Access Compliance Report Public Rights-of-Way (Curb Ramps)

Main Street: AUBURN_AVE Cross Street: SANDHURST_ST Location: SE

ADA ID: RPAT211006133116 Ramp Type: Type 6 - Directional 1 Initial Pass/Fail: Pass Overall Compliance: No Severity Score: 18

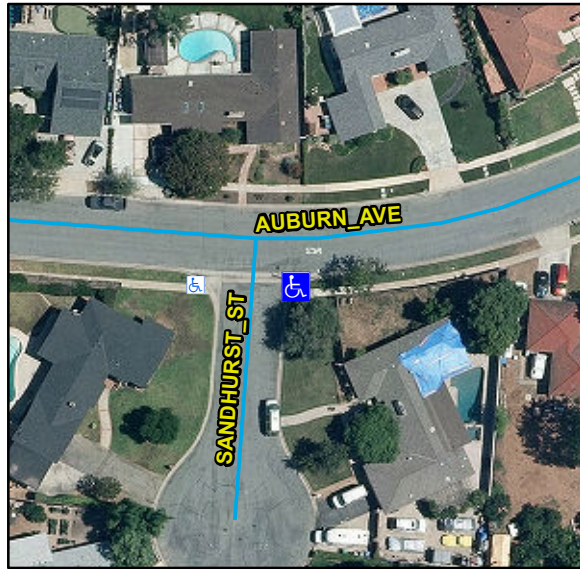
R304.2.1, R304.5.3, R304.5.2, R305, STD 1115

Remove & Replace Curb Ramp With Two New Directional Ramps or Equivalent. Utility Present.
